## PLANNING COMMITTEE

### ADDENDUM TO THE OFFICER'S REPORT

**15/07932.OUT – North London Business Park, Oakleigh Road South N11 1GN.  
Pages 79-160**

#### **Land Adj To 1 - 12 Norfolk Close N2 8ET (East Finchley)**

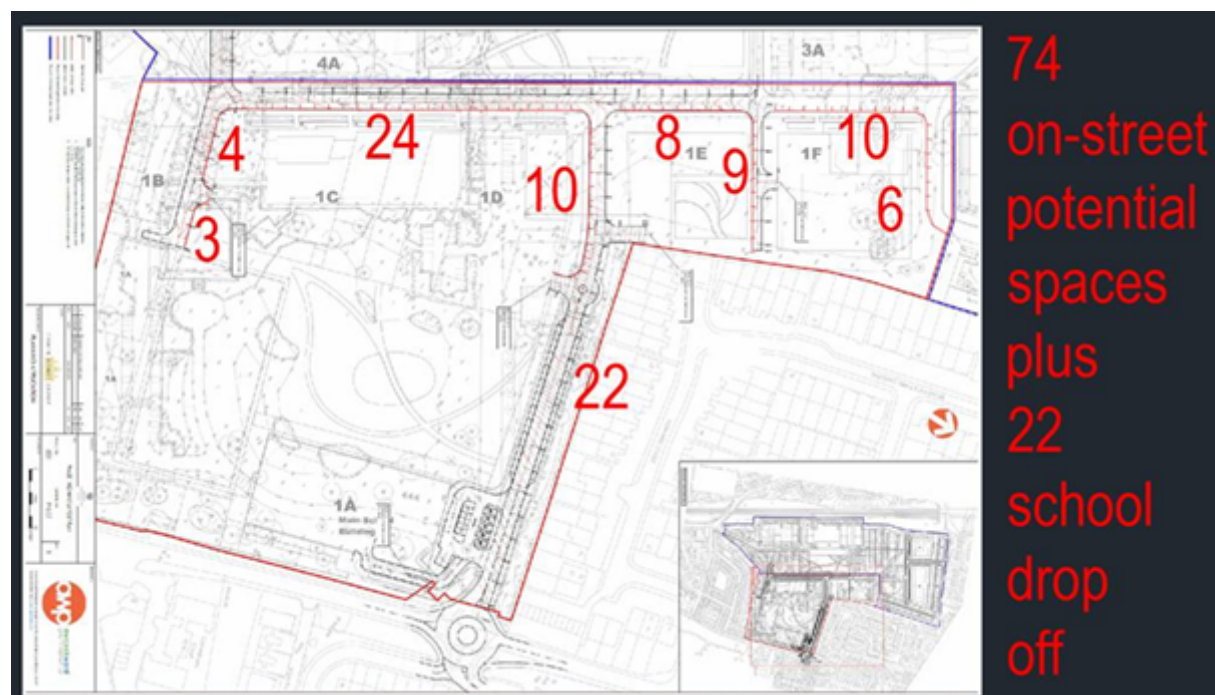
As shown on our attached plan PS/01 in Phase 1 parking is located beneath Blocks 1C/D and 1E/F.

Accessible (disabled / blue badge) parking will be provided at a ratio of 10% of total spaces as below:

Accessible parking will be arranged within the basement car parks to be as close to each individual core as possible, to reduce the distance travelled by a disabled person to their vehicle. Further, clear routes which avoid traffic must be provided between the core entrances

and the accessible spaces to avoid potential conflicts with vehicles and this is particularly pertinent when considering wheelchair users.
